DRAINAGE REPORT

PROJECT: 22A267

**Town of Ramah Wastewater
System Improvements**

DATE: October 27, 2023

South Swale 100-Year

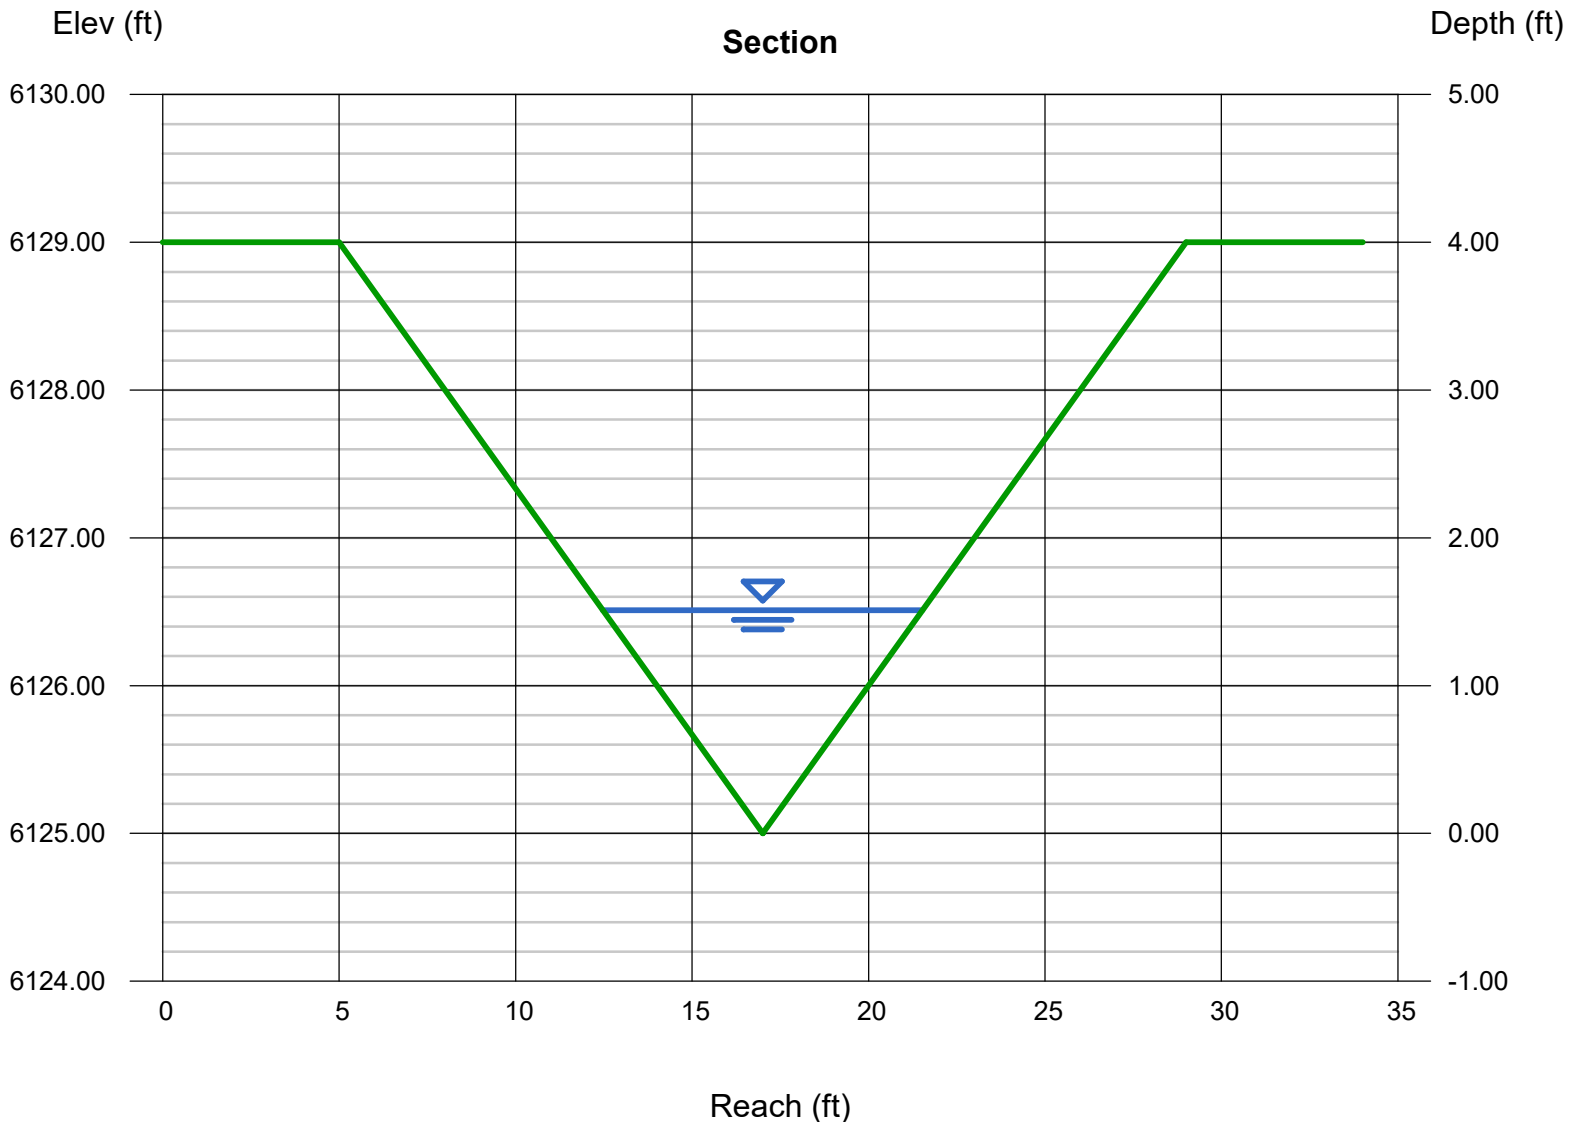
Discuss if swale requires lining due to velocity per El Paso County DCM Volume 1 Section 3 Chapter 10.3

PROPOSED DRAINAGE PLAN

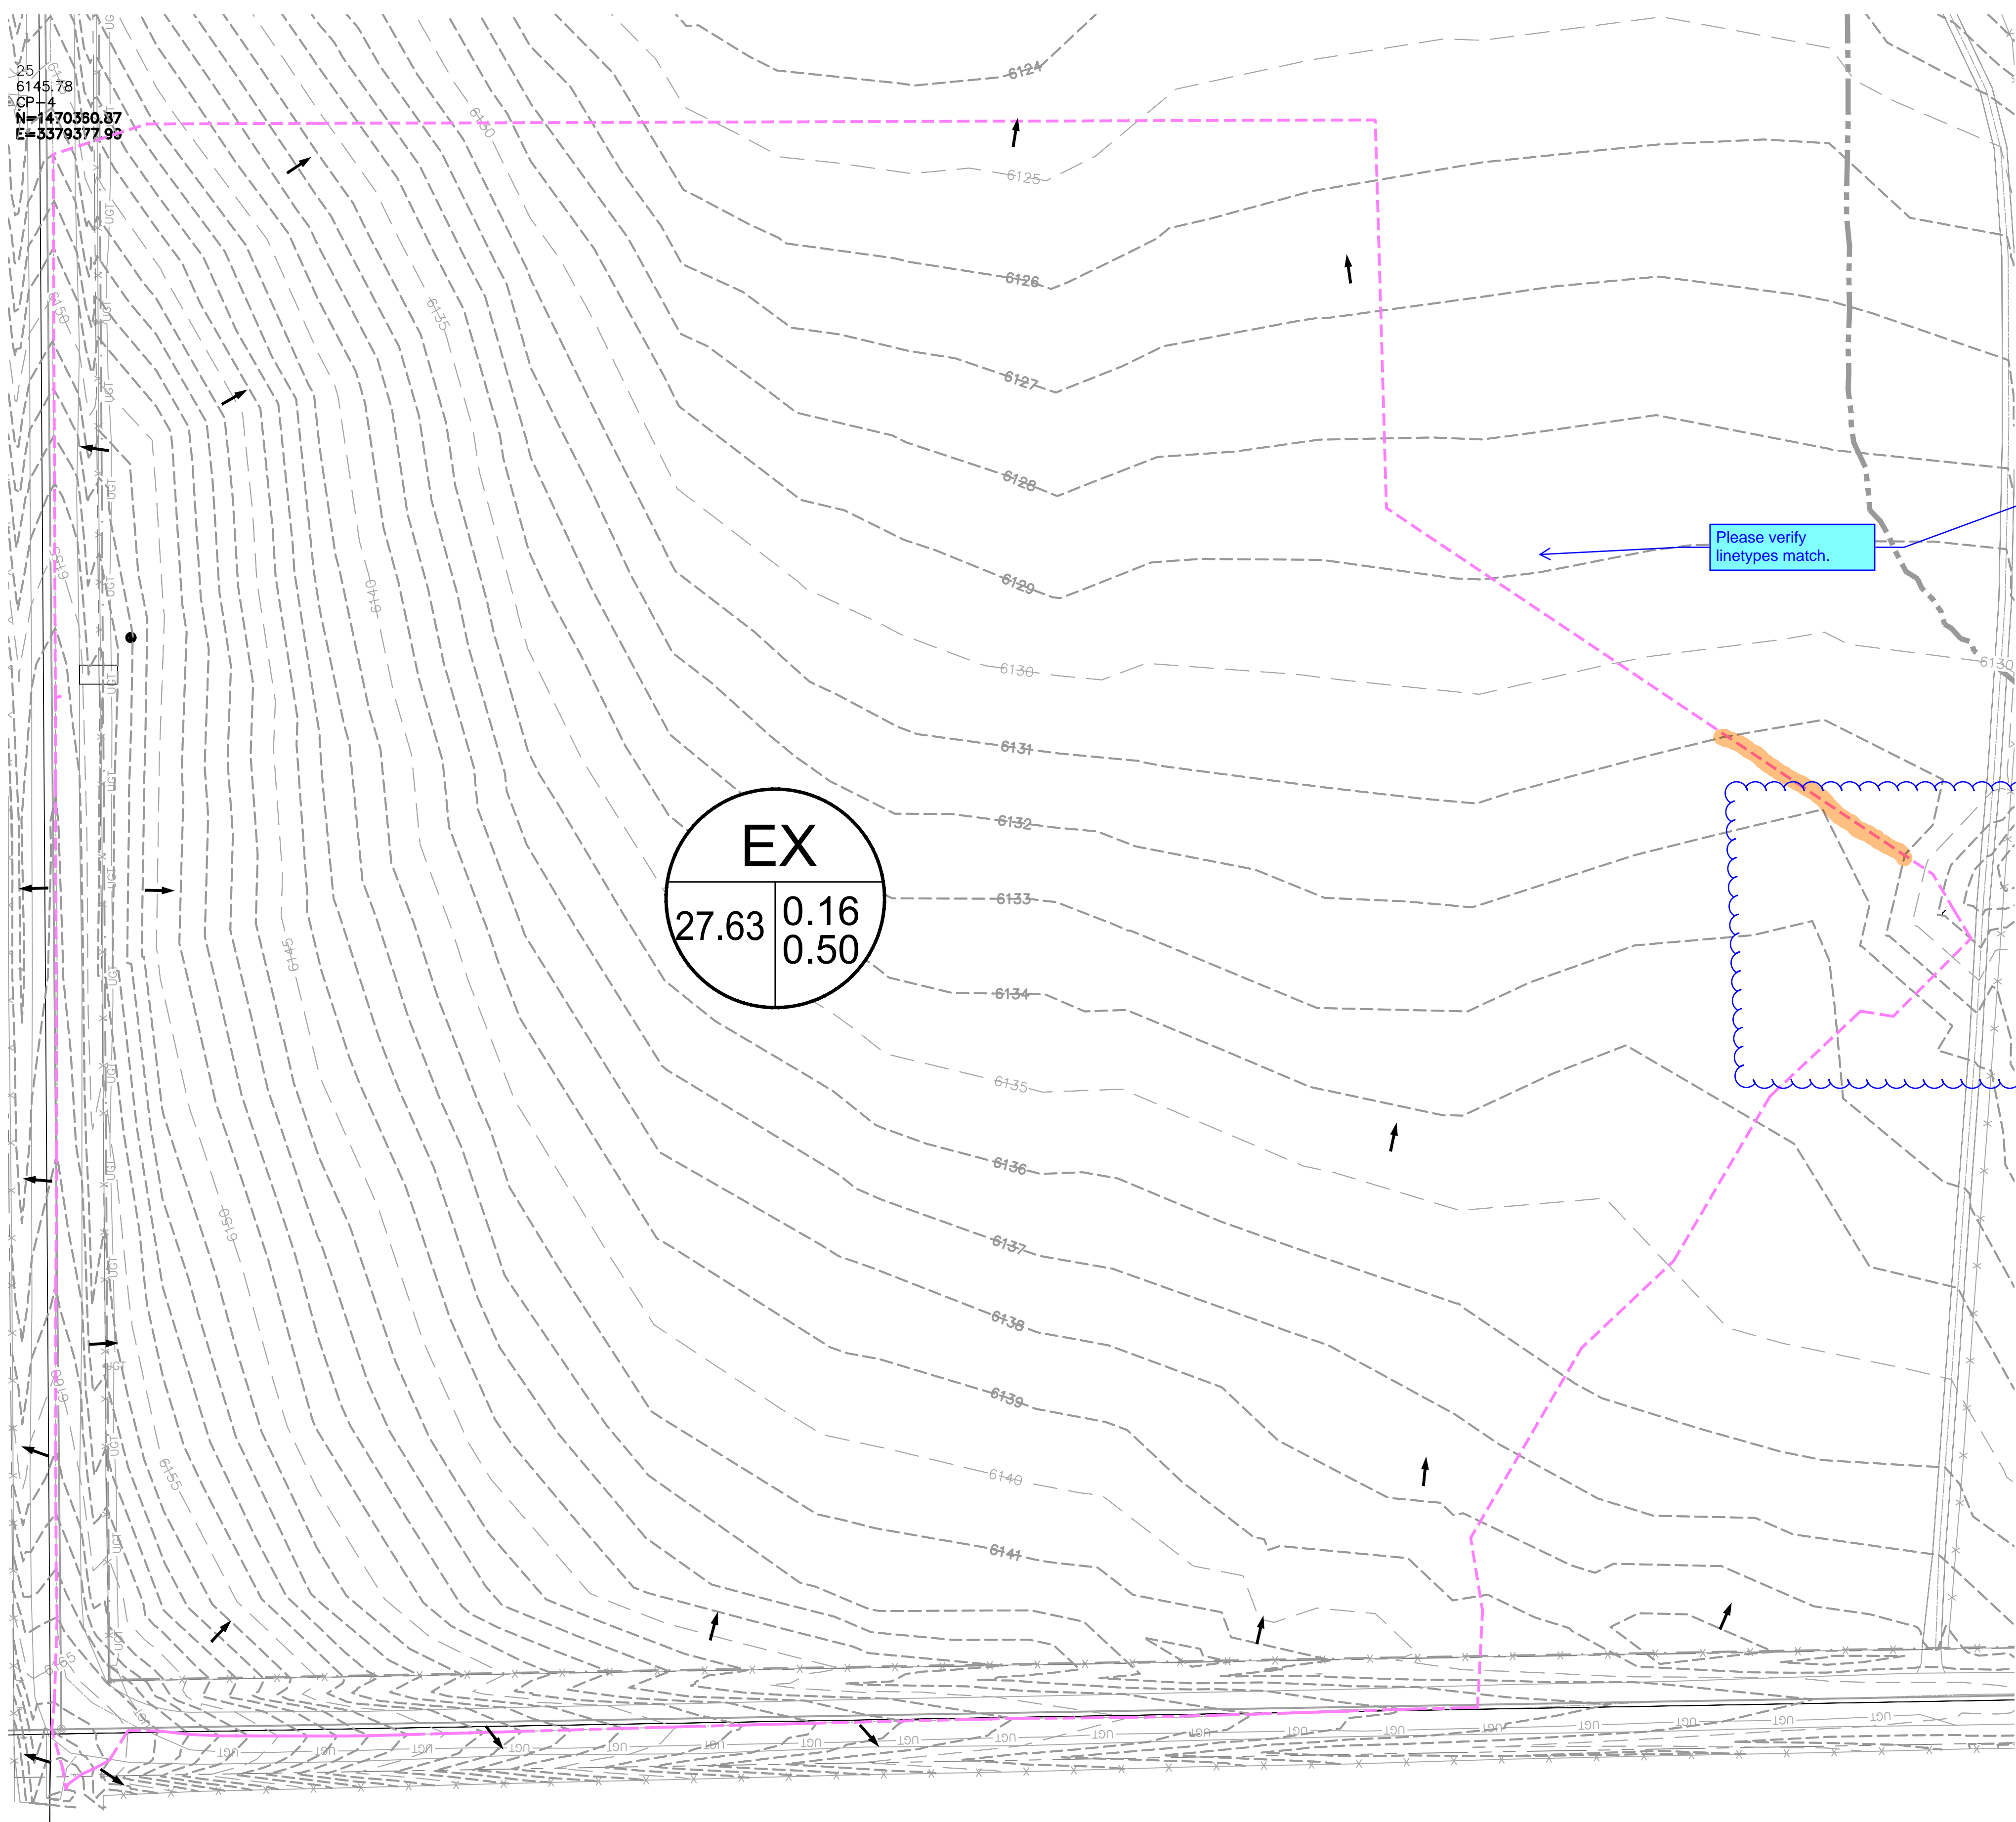
Please verify linetypes match.

Basin boundaries should not intersect the same contours twice. Please verify and update basin boundaries.

Please show and label all existing and proposed drainage infrastructure. Label all pertinent information such as material, size, type, shape, and slope.

Per ECM Chapter 3.2.4 please include in the final drainage report a discussion addressing suitable outfall location criteria. In existing conditions stormwater runoff sheet flows towards the north. In the proposed conditions design point 2 is now a concentrated flow. Please analyze the impact to the from the concentrated flow. Address ultimate suitable outfall and if it can receive developed flows without negative impacts to streambed stability and/or natural sediment transport functions. Include calculations to show the outfall is hydraulically adequate, and provide possible improvement recommendations (i.e. culvert, grading, etc). Note: Page 2 of the geohazard report identifies erosion occurring in this area.
